**DEVIATION REVIEW
 AND DECISION FORM**

Deviation No. 3
REV. 2-8-2019

Subdivision or Project Name: Rollin' Ridge Estates

Section of ECM from Which Deviation is Sought: 2.3.7.E Intersections - Turn Lane Design

C1.3

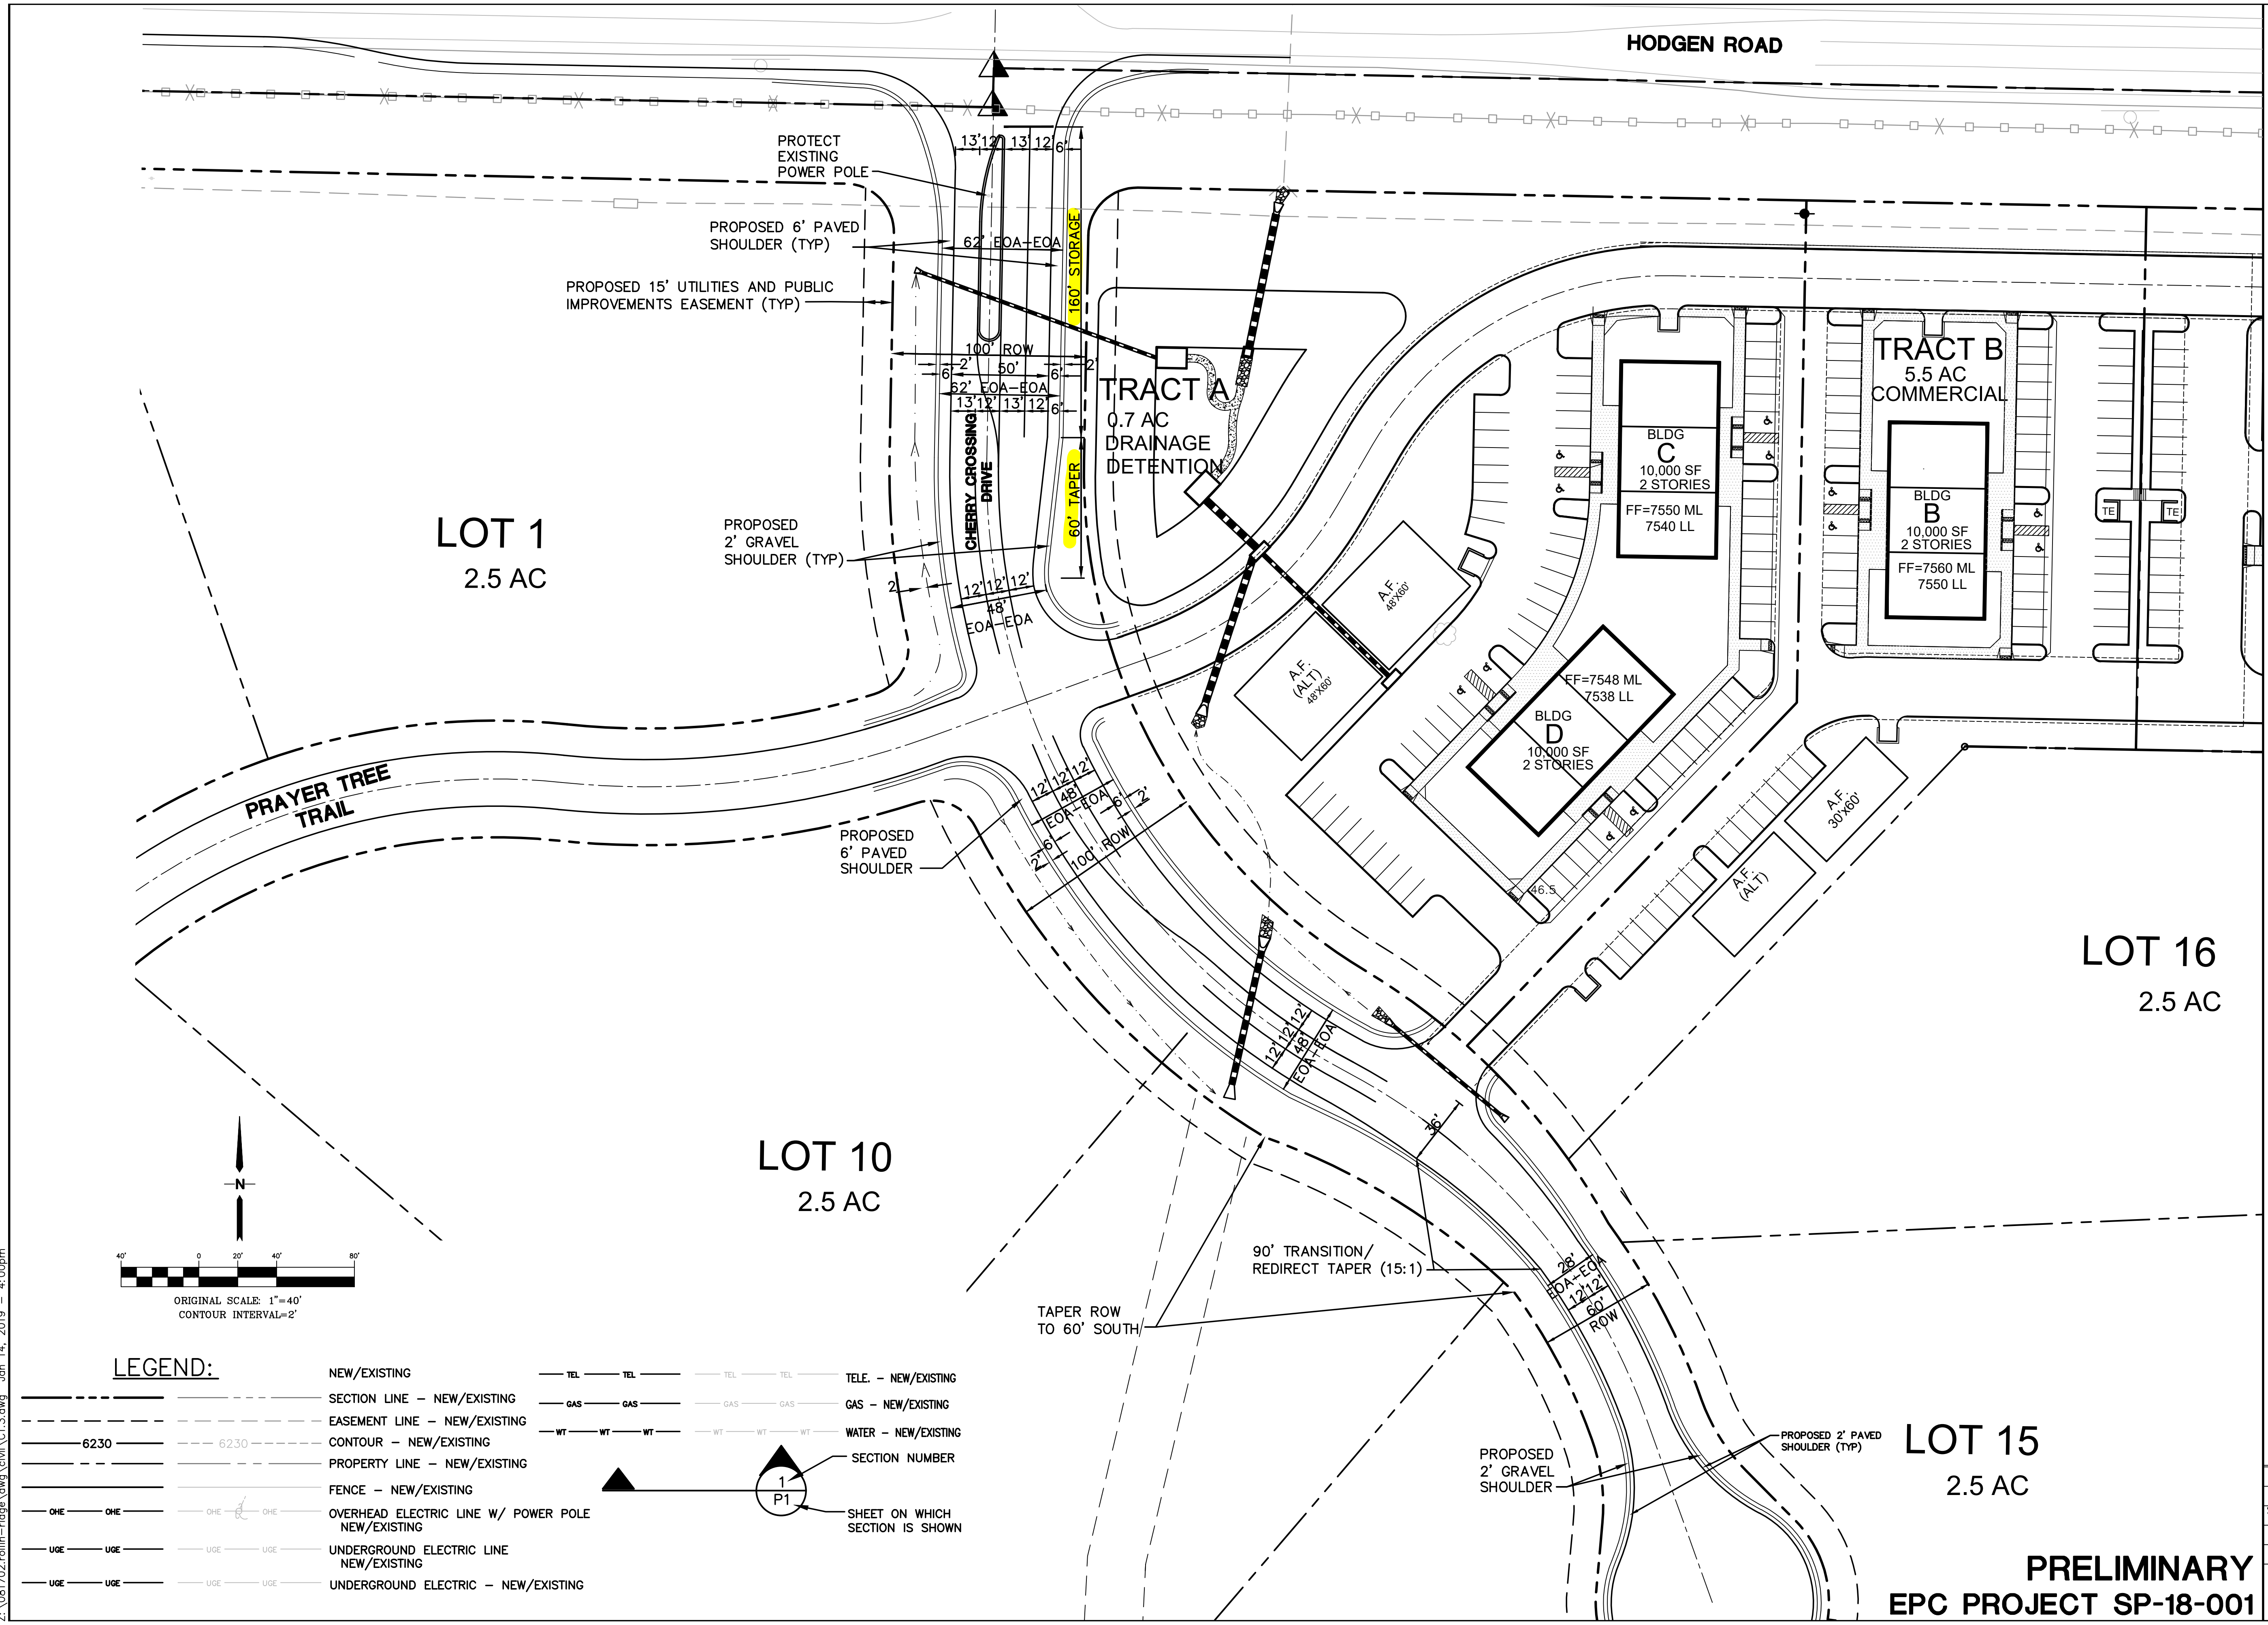
Staff would prefer a continuous lane. Please update the plans and traffic study.

Staff would prefer a continuous lane. Please update the plans and traffic study.
